Your Ref:DC/19/03486
Our Ref: SCC/CON/3036/19
Date: 7 January 2020

CONSULTATION RETURN: DC/19/03486

PROPOSAL: Outline Planning Application (some matters reserved - access to be considered) -

LOCATION: Land south west of Beyton Road Thurston Suffolk

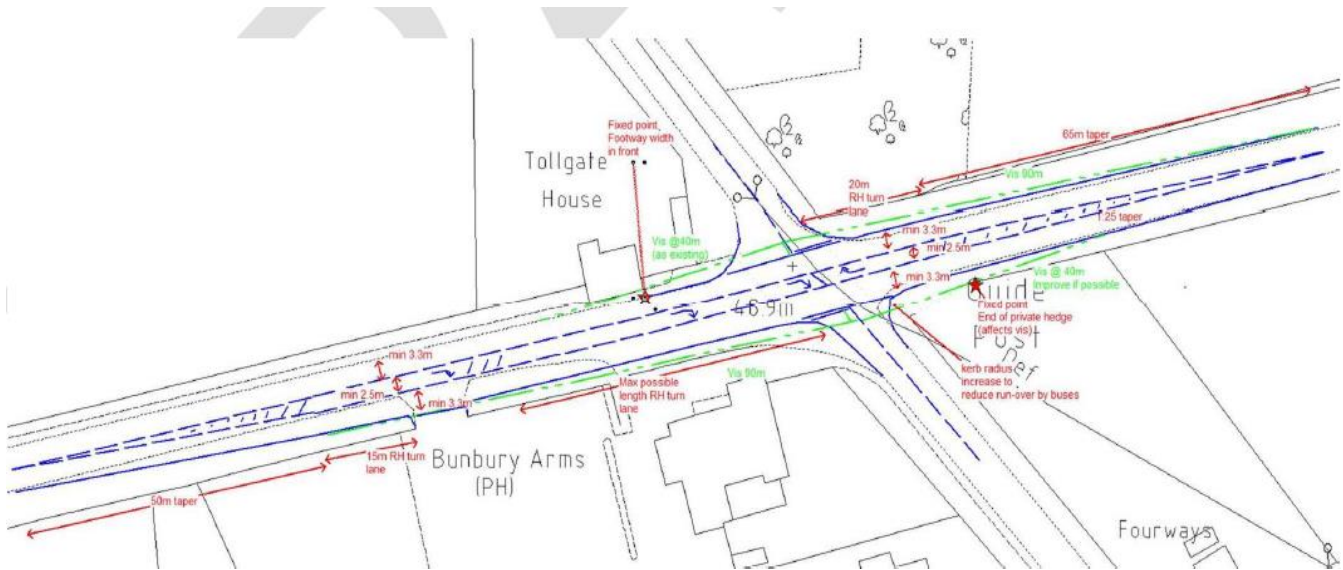
The report concluded that the 2 developments shows Barton Road/Station Hill mini roundabout, Fishwick Corner and Pokeridge Corner junctions would all be close to or over capacity. With proposed mitigation from the Beyton Road development, these junctions all operate within desired capacity limits for future year 2024.

A143/C691 Bunbury Arms junction

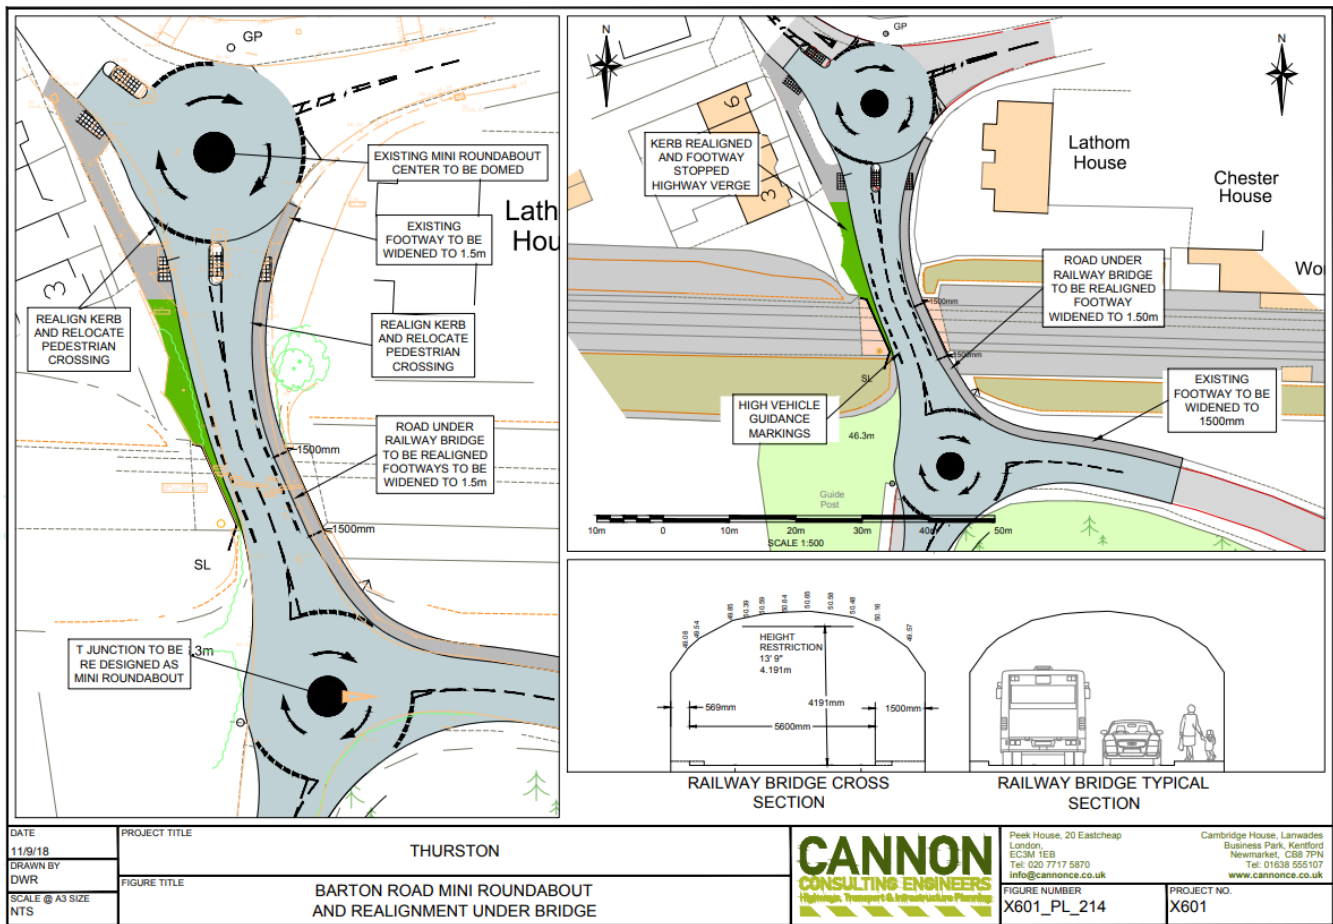
Existing situation	Proposed mitigation
<p>The mitigation from the 2017 developments included signalling the junction. The junction will be at capacity on two arms in the AM peak hour for the granted applications. This was accepted as the developments had mitigated their impact, but it was not possible to fully mitigate the background growth due to space constraints.</p>	<p>The proposed mitigation with contributions from the previous 5 applications, the 2019 AECOM indicates that the one arm of the junction will be over capacity during the AM peak hour and at capacity on two arms. On further assessment of the model data, we believe there is scope to improve the proposed preliminary design of the signals using better software and monitoring systems to improve capacity. However, no further mitigation, in terms of highway layout, is considered possible within the highway boundary.</p>

The impact on this junction is minimal from this development’s traffic as the dominate movement is south or west; towards the A14. Modelling in the applicant’s Transport Assessment shows the junction percentage impact from this site would be less than 1%. It has been assumed that the direction of trips can be based on census data showing their destination. Also, due to its location south of the railway line, it is likely that drivers are more likely to travel via the A14 to reach destinations West and North of Bury St Edmunds and trips via the Bunbury Arms Junction will be less than anticipated.

We also believe that the provision of a signal junction at the A143 junction will potentially result in a redistribution of traffic due to the additional delay for left turn out movements. The signals could also increase the right turn movements from Thurston, as it becomes more attractive manoeuvre no longer being directly opposed.

C693 Thurston Road/C692 Thurston Road junction (Fishwicks Corner)

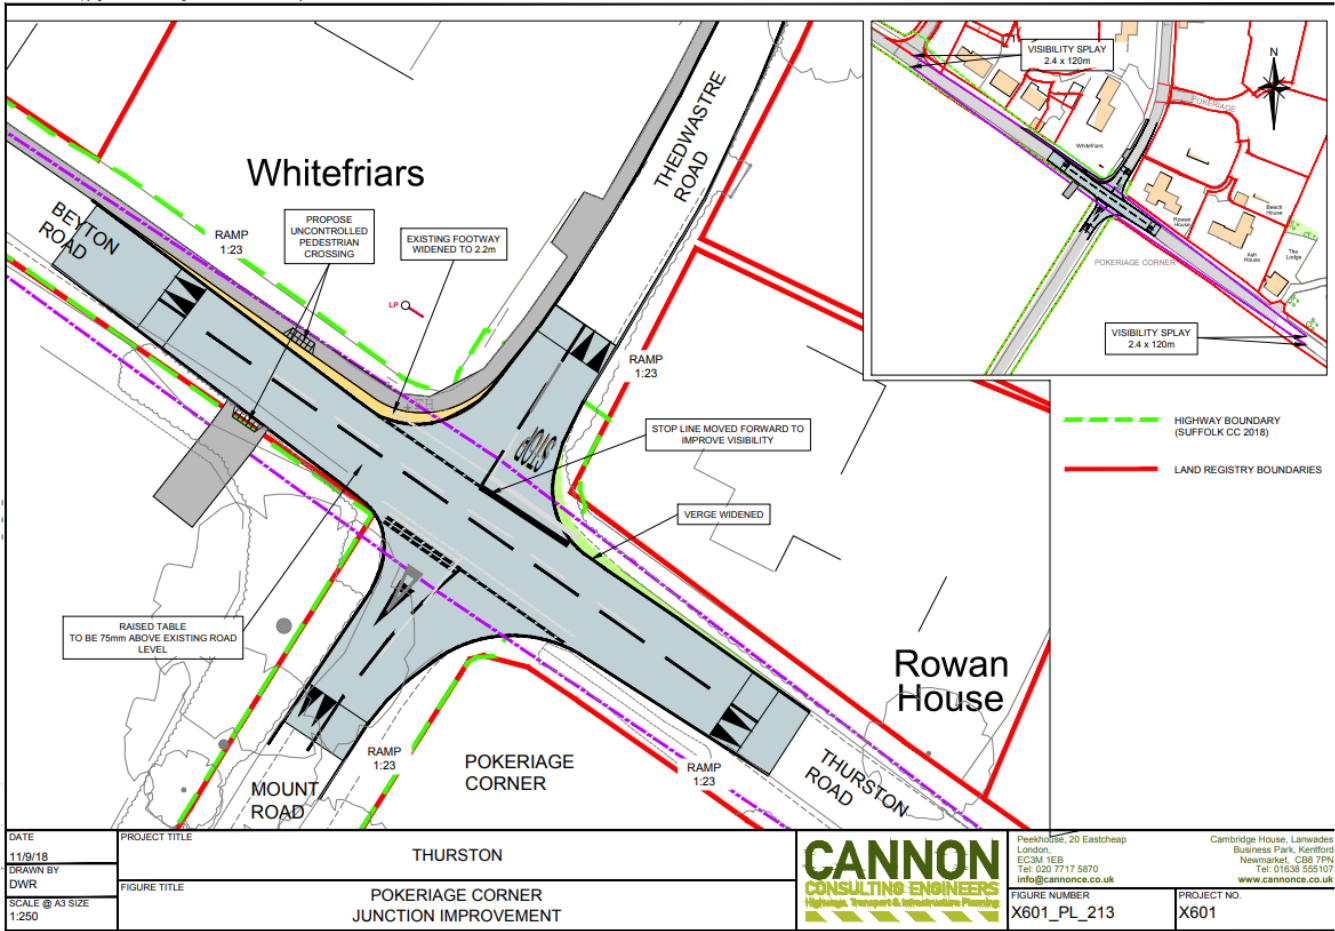
Existing situation	Proposed mitigation
<p>At Fishwicks Corner the primary cause for congestion is due to limited visibility at the junction. Being a crossroads with four-way movements also reduces capacity and adds to delays. The junction is an accident cluster site with 13 recorded injury accidents; 11 of which were drivers failing to look properly on the minor arms of the crossroads due to poor forward visibility. As part of the mitigation for the 2017 developments, a 40mph speed limit is being introduced with a change in the junction priority and altering the give-way scenario to Stop lines on the side roads. The predicted RFC with the 2017 developments following the revised layout of the junction was calculated as 0.93 in the PM peak.</p>	<p>The land to the north west of the junction is within the developers control so the highway boundary is no longer a constraint for further highway improvements to improve safety and capacity of the junction. The dominant turning movement in the AM peak is from Thurston Road (north arm) turning right to Bury St. Edmunds and in the PM peak, from Bury St Edmunds turning left into Thurston Road (north arm). By introducing a staggered junction, this improves the RFC for Base + Committed Development + the Development from 1.10 t(unmodified) o 0.58 and reducing delays by approx. 3 minutes therefore, improving capacity. Also, staggered junctions will provide the required visibility for the speed of road (40mph) and this type of layout has been shown to reduce accidents by some 60% compared to a crossroads. Recently, a preservation order has been applied to trees next to the existing junction but these are unaffected by the proposed new junction</p>

The question of a roundabout in this location has been raised by councillors. While an acceptable solution it is not concerned proportionate to the scale of the development as the proposal for a staggered junction delivers sufficient mitigation. Also, a roundabout would require a large area of land, are less safe for cyclists than to any other kind of road layout and there would be a need to remove more trees. possibly those recently protected. SCC have also requested additional area of land to be secured to allow for a future cycle/footway scheme if that is considered necessary.
